Department of Environmental Quality  
Division of Radiation Control

January 21, 2003

SUBJECT: September 2002 Final Site Observational Work Plan for the Green River, Utah  
UMTRA Site: DRC Comments

# July 2002 Potentiometric Surface of Cedar Mountain Middle Sandstone Unit including water level in well 180 Green River UMTRA Site

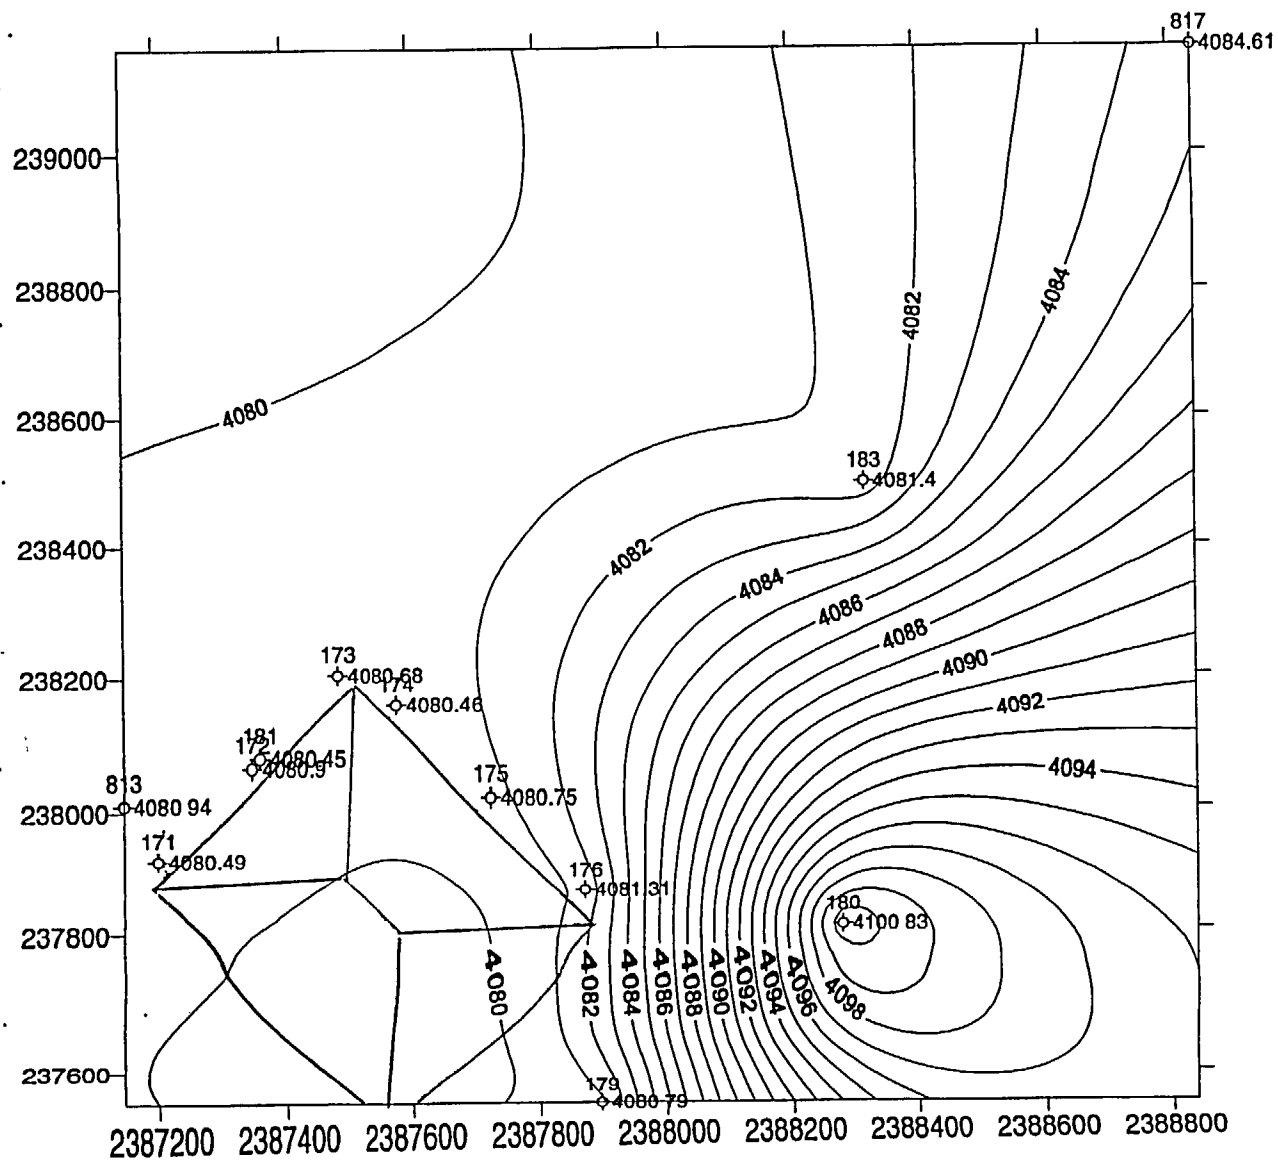
Northwest Hydraulic Gradient. After constructing a series of cross sections and correlating the sandstone units beneath the site, DRC staff constructed a map of the potentiometric surface for the middle sandstone unit of the Cedar Mountain Formation (Attachment 1). The data used for this map are summarized in Table 1 below with other hydrogeologic data.

The hydraulic gradient in Attachment 1 is consistent with the hydraulic gradient provided by the DRC in 1996 (Attachment 2). Both DRC maps include well 0180 as a data point and show an overall northwestward flow direction with a relatively flat hydraulic gradient in the vicinity of the disposal cell and a steep gradient east of the disposal cell. It is interesting to note that the hydraulic head in well 0180 has changed very little in seven years from a value of 4100.95 feet amsl in June 1995 to a value of 4100.83 in July 2002. Geologic cross sections and boring log correlations indicate that the well screens in monitoring wells 0177 and 0178 are completed in a different sandstone aquifer, referred to by DOE as lenticular stringer sandstones of the lower unit of the Cedar Mountain Formation. Based on lithologic descriptions, stratigraphic position, and geochemical signatures, the DRC concurs that the lower Cedar Mountain stringer sandstone aquifer is hydraulically connected with the Cedar Mountain basal sandstone unit, but hydraulically separated from the Cedar Mountain

middle sandstone unit. As a result, water levels for wells 0177 and 0178 were not included in the July 2002 potentiometric surface of the Cedar Mountain middle sandstone unit (Attachment 1).

The northwest hydraulic gradient depicted in Attachment 1 is supported by fracture and joint patterns at the Green River site and the structural dip of the middle sandstone unit. Figure 5-6 of the Final SOWP indicates a predominant northwest orientation of fractures and joints at the Green River site, which supports a northwest groundwater flow direction. In addition, a structure contour map constructed on top of the middle sandstone unit indicates a northern structural gradient with a slight northwest dip component in the vicinity of the disposal cell (Attachment 4). The combination of a northern structural gradient with a northwest fracture orientation is consistent with the northwest hydraulic gradient in Attachment 1.

If the hydraulic gradient is to the northwest as indicated by DRC Attachment 1, proposed POC wells 0171, 0173, 0181, and 0813 are adequate locations for monitoring ACLs for the Cedar Mountain middle sandstone unit. Although proposed POE well 0182 is in an appropriate location for a northwest hydraulic gradient, this well is screened across the basal sandstone unit of the Cedar Mountain Formation, not the middle sandstone unit. Because the basal sandstone unit of the Cedar Mountain Formation has a strong upward hydraulic gradient and is hydrogeologically isolated from the middle sandstone unit, it has not been contaminated by site-related activities. As a result, well 0182 cannot serve as a POE well for the Cedar Mountain middle sandstone unit. Therefore, a POE well needs to be installed near the downgradient edge of the State property boundary with a screened interval across the middle sandstone unit of the Cedar Mountain Formation.

**July 2002 Potentiometric Surface of Cedar Mountain Middle Sandstone Unit  
excluding water level in well 180  
Green River UMTRA Site**

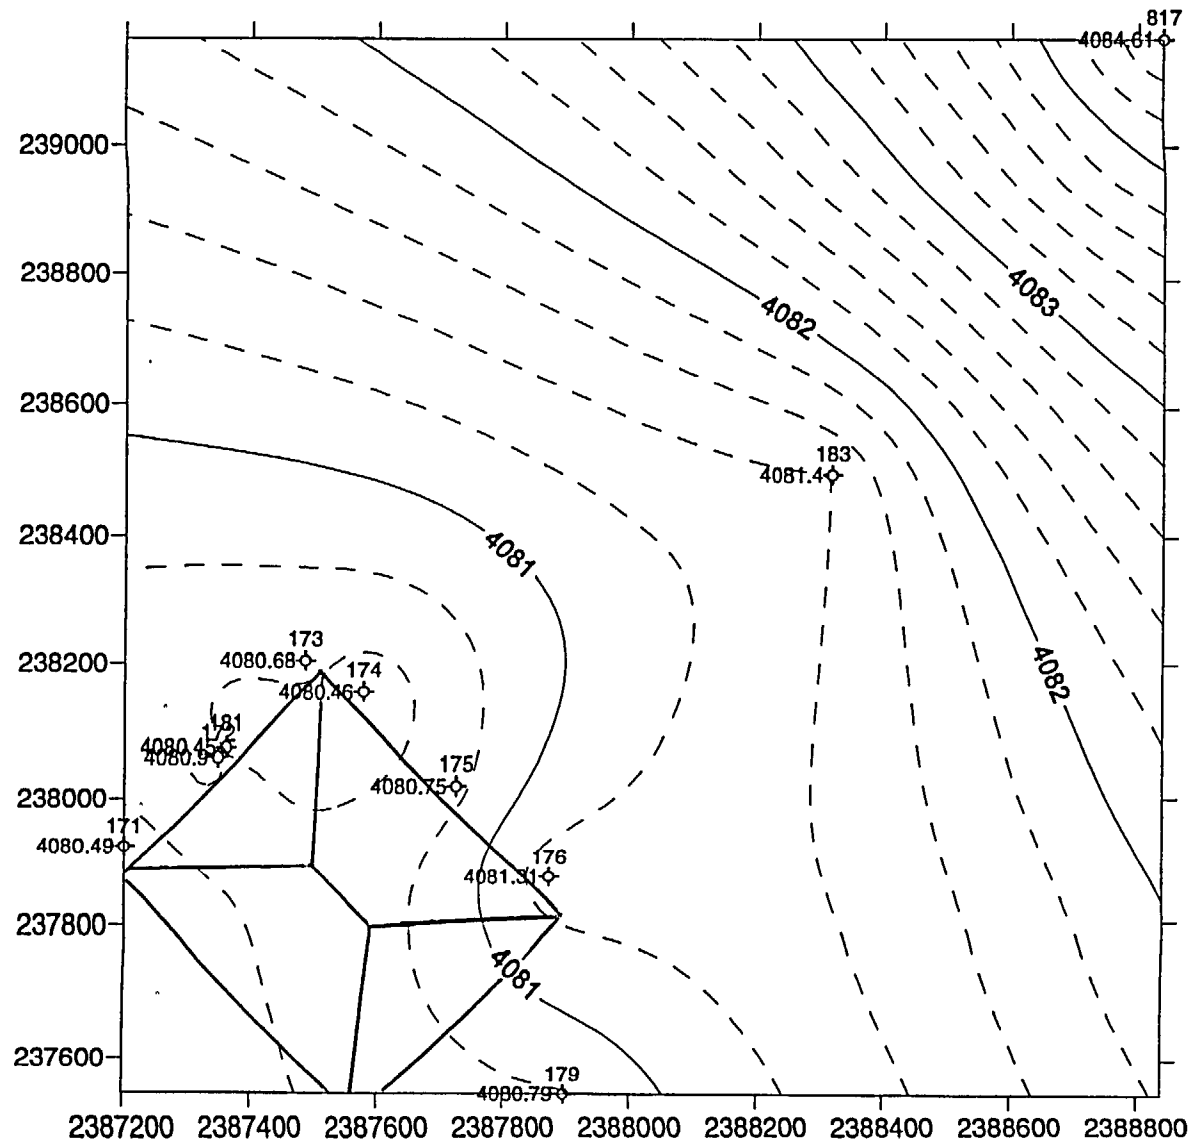
Southwest Hydraulic Gradient. Figure 5-9 of the Final SOWP depicts a southwest hydraulic gradient towards the Green River regional discharge area. The difference between the potentiometric surface depicted in DRC Attachment 1 and Figure 5-9 of the Final SOWP is caused by the presence or absence of the head measurement in well 0180. The DRC map in Attachment 1 includes the head elevation in well 0180 while Figure 5-9 of the Final SOWP does not. By removing the head measurement of well 0180 from the data set, DRC staff replicated the potentiometric surface in Figure 5-9 of the Final SOWP (Attachment 3). However, correlations of boring logs in DRC cross sections show that the middle sandstone unit of the Cedar Mountain Formation is present in well 0180 from 4079.20 and 4067.20 feet elevation above mean sea level (amsl). This sandstone correlates with the sandstone present from 4113.70 to 4073.70 feet amsl in well 0179 to the southwest, and the sandstone present from 4030.00 and 4011.00 feet amsl in well 0183 to the northeast. Because wells 0179, 0180, and 0183 are all completed in the middle sandstone unit of the Cedar Mountain Formation, the water level elevation measured in well 0180 should be included in the potentiometric surface map for the middle sandstone unit of the Cedar Mountain Formation.

Hydraulic Gradient Implications for an ACL Compliance Strategy. As stated above, an adequate characterization of the hydraulic gradient of the Cedar Mountain middle sandstone unit is critical for establishing POCs and POEs for an ACL compliance strategy. If the hydraulic gradient is to the southwest as indicated in Figure 5-9 of the Final SOWP, the proposed POC wells are inappropriate because they are located crossgradient of the disposal cell. In addition, there are no monitoring wells completed in the Cedar Mountain middle sandstone unit that are appropriately located to serve as a POE well for a southwest hydraulic gradient. Consequently, DOE will need to install new POC wells immediately downgradient of the disposal cell (southwest side), and a POE well will need to be installed near the downgradient edge of the property boundary.
